ISSUE: Certificate of Appropriateness for alterations and painting of unpainted masonry

APPLICANT: EAHG Alexandria LP

LOCATION: Old and Historic Alexandria District
625 First Street and 510 Second Street

BAR #2021-00470
625 First Street and 510 Second Street

Figure 3: Building phases

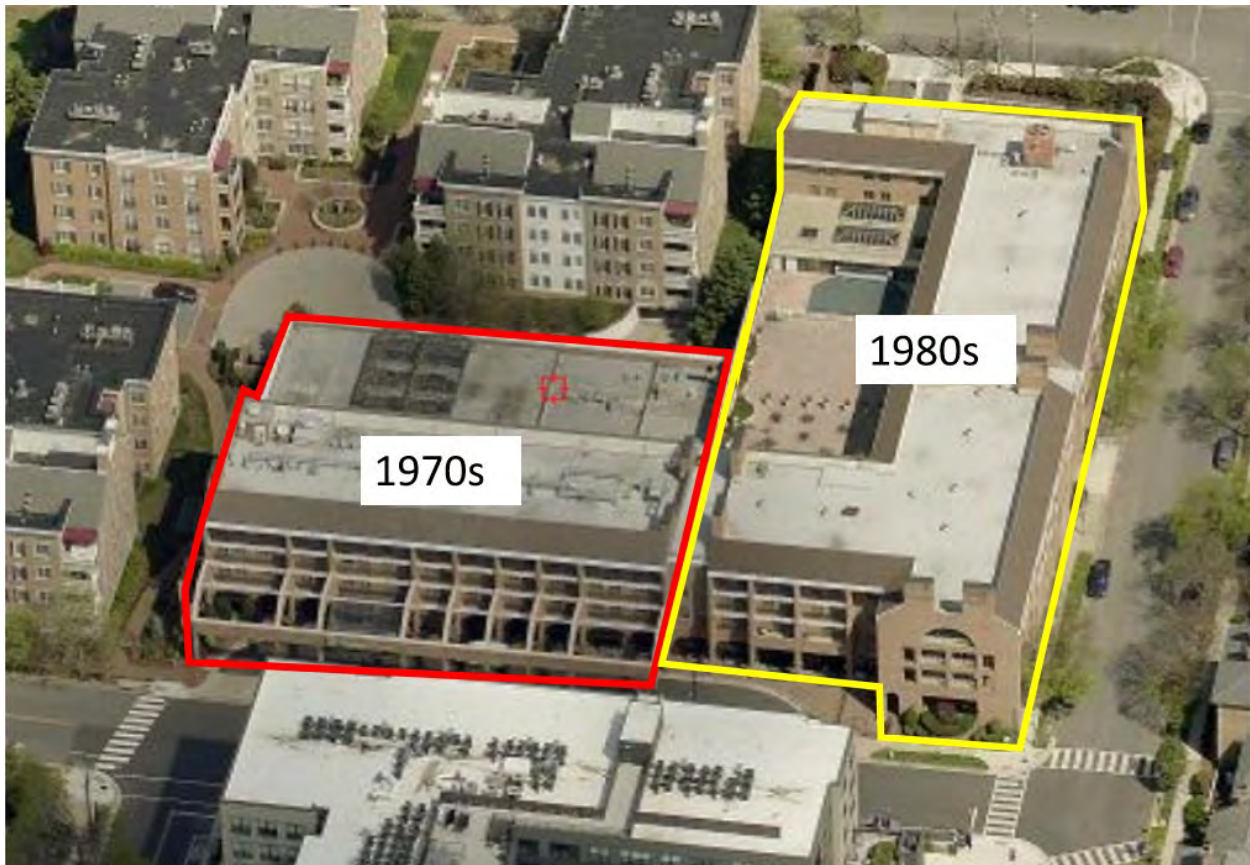
The hotel at 625 First Street has frontage on both First and N. Pitt Streets and was constructed in two phases. The first phase of the building was constructed as an addition in the **late 1970s** as part of the Old Colony Inn, which once occupied this site as well as the land to the west and north. The second phase of the hotel was constructed in the **mid-1980s** when the larger portion was constructed fronting on N. Pitt Street (Figure 1).
